**FEDERAL COMMUNICATIONS COMMISSION**  
445 TWELFTH STREET, SW  
WASHINGTON, DC 20554

Re: WCOT(FM); Jamestown, NY  
Facility ID No.: 20653  
Family Life Ministries, Inc.  
BPED-20000619AEQ

This letter refers to the above-captioned application filed by Family Life Ministries, Inc. ("Family Life") to make changes to noncommercial educational FM station WCOT(FM). For the reasons set forth below, Family Life's application is not acceptable for filing and will be dismissed.

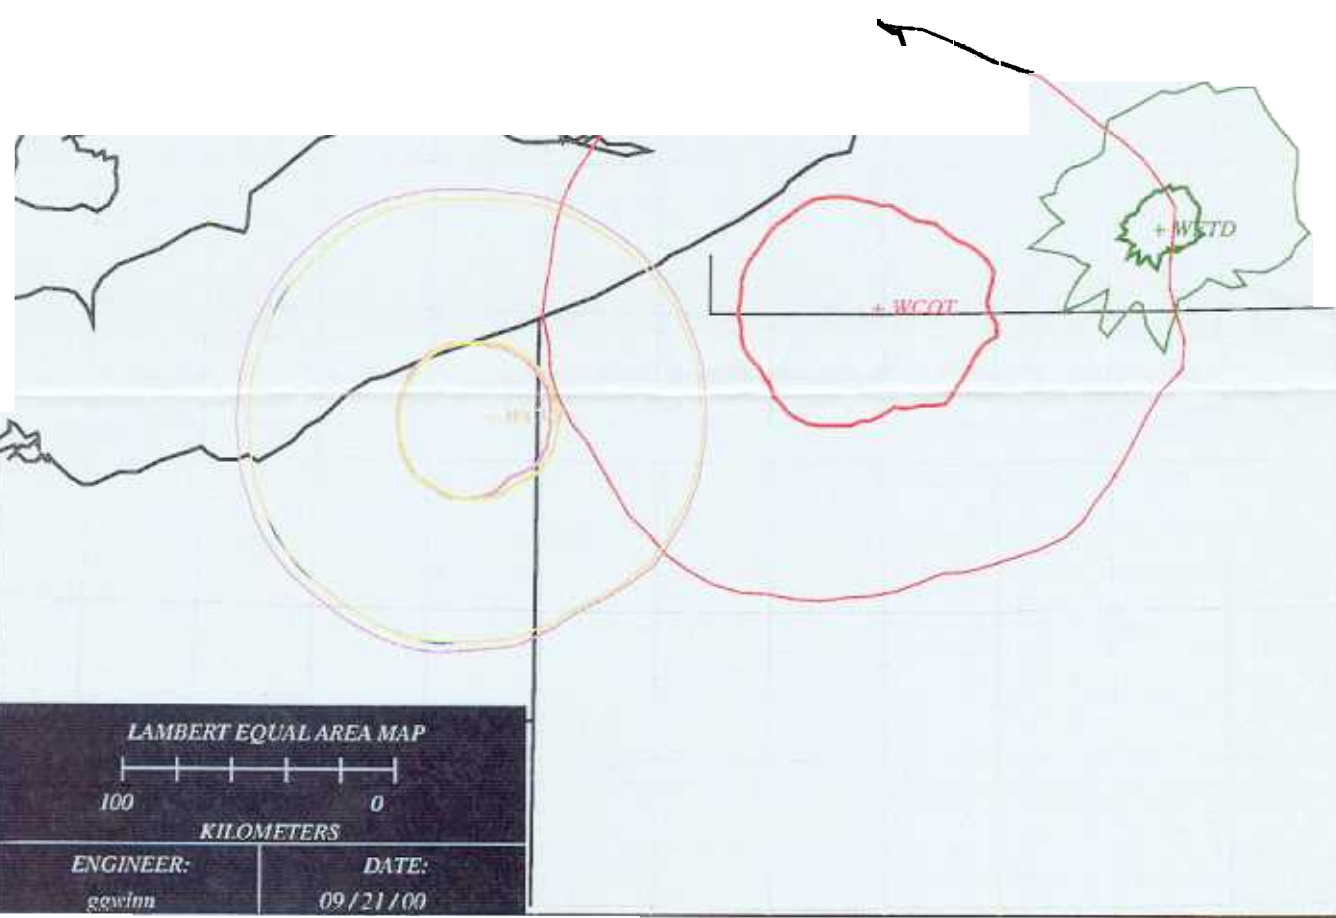
An engineering study of the application reveals that it is in violation of 47 CFR § 73.509 with respect to the State University of New York's ("SUNY") co-channel Class A station WETD(FM), Alfred, NY. Specifically, the proposed interfering contour (40 dBu) would overlap the protected contour (60 dBu) of WETD's licensed facility, BLED-19820422AH (See enclosed FM Overlap Study). Family Life acknowledges this predicted contour overlap, and requests contingent processing with a "concurrently" filed permit application by SUNY for station WETD that proposes to change the channel assignment from 215A to 214A and thereby eliminate the predicted overlap.<sup>1</sup>

In light of the above, Application BPED-20000619AEQ is unacceptable for filing pursuant to 47 CFR § 73.3566(a) and is **HEREBY DISMISSED**. This action is taken pursuant to 47 CFR § 0.283.
